Redmond School District

SPECIAL EDUCATION BUILDING PROJECT

ADDENDUM No. 2

January 20, 2026

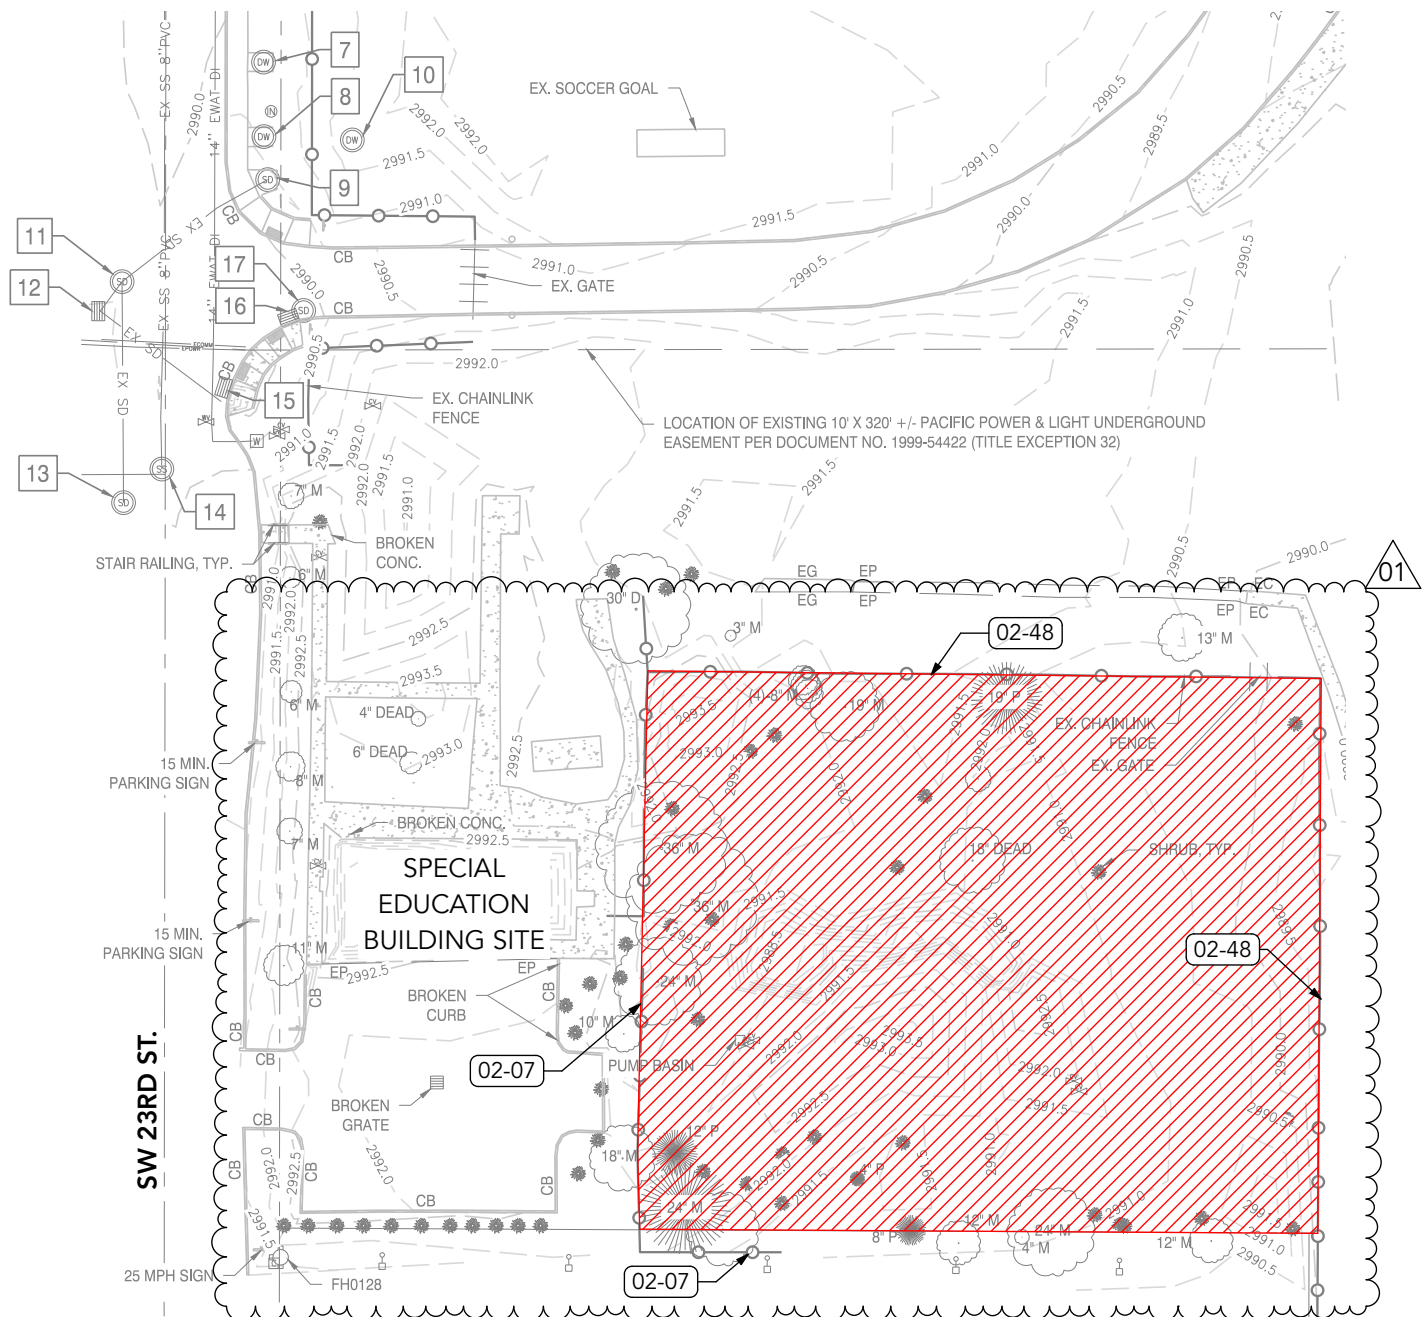
IN THE AREA INDICATED, PROVIDE ALL LABOR, MATERIALS, EQUIPMENT, PERMITS, AND SUPERVISION NECESSARY TO DEMOLISH AND REMOVE EXISTING SITE INFRASTRUCTURE (INCLUDING PONDS, PIPING & PUMPS), SHRUBS AND PLANTINGS, FENCES & GATES TO THE NORTH AND EAST AND TO LEAVE THE SITE FLAT, LEVEL AND READY FOR FUTURE CONSTRUCTION. ALL EXISTING TREES AND FENCING TO THE WEST AND SOUTH TO REMAIN.

- 02-07 (E) CHAIN LINK FENCE TO REMAIN
- 02-48 (E) CHAIN LINK FENCE TO BE DEMOLISHED
